EASTONVILLE ROAD FROM LONDONDERRY DRIVE TO REX ROAD SEGMENT 1 IMPROVEMENTS STATIONING 14+19.69 - 47+66.51

OVERALL SHEET INDEX	
SEGMENT 1	SHEETS 1-42
SEGMENT 2	SHEETS 43-96

EDARP FILING NO. CDR2321

SHEET
PD.1
 18

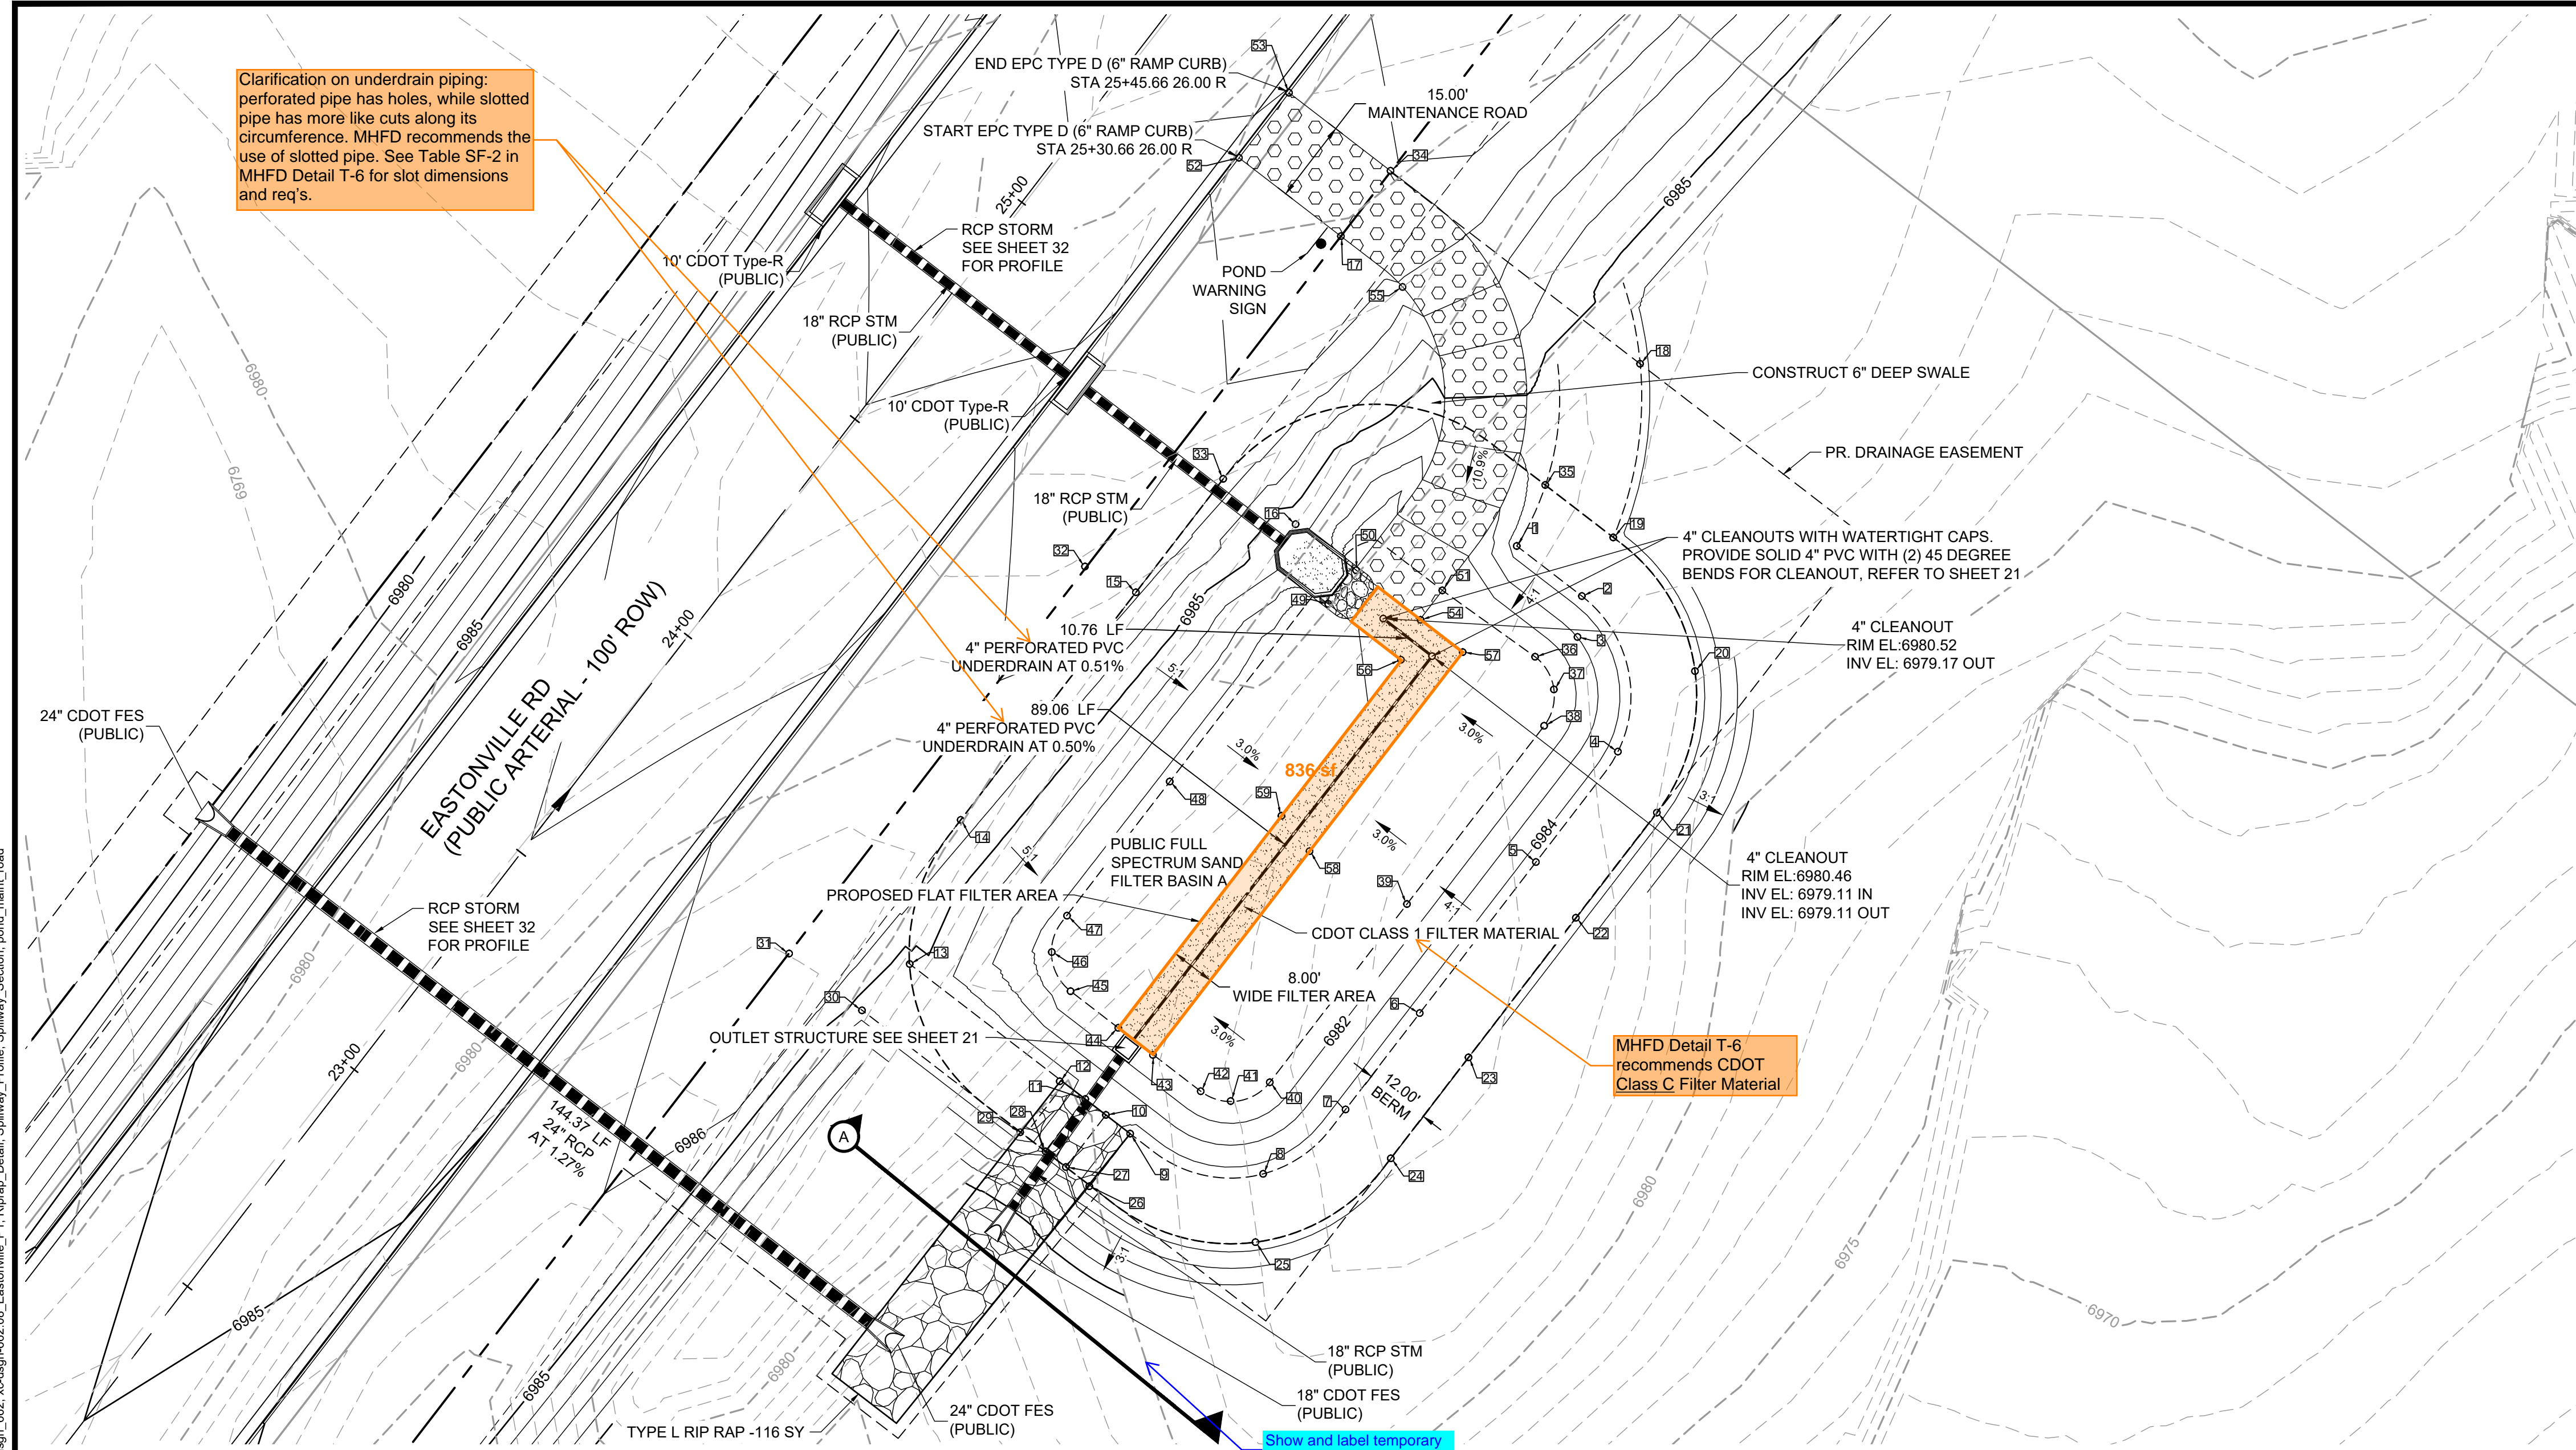
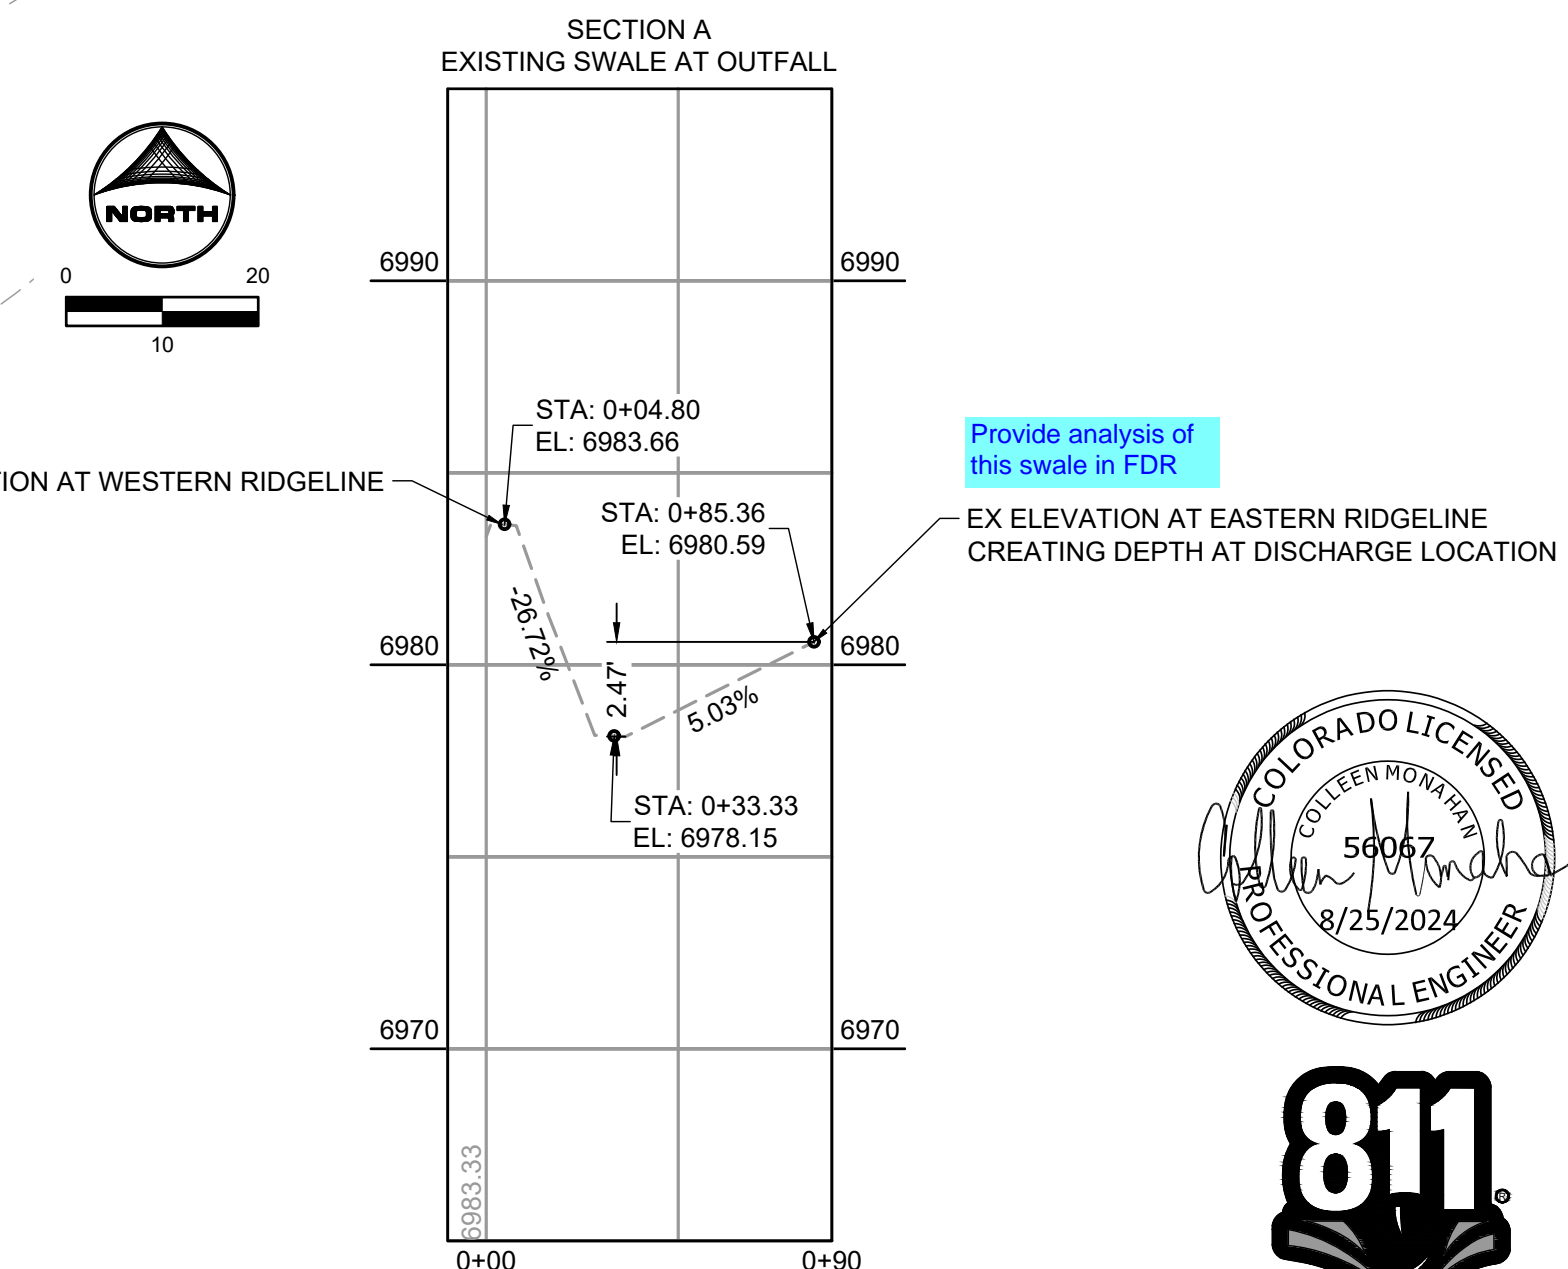
Subject: SW - Textbox with Arrow
Page Label: [18] 18 SFB A (PUBLIC) GRADING PLAN MHFD Detail T-6 recommends CDOT Class C Filter Material
Author: Glenn Reese - EPC Stormwater
Date: 9/10/2024 4:02:34 PM
Status:
Color: ■
Layer:
Space:
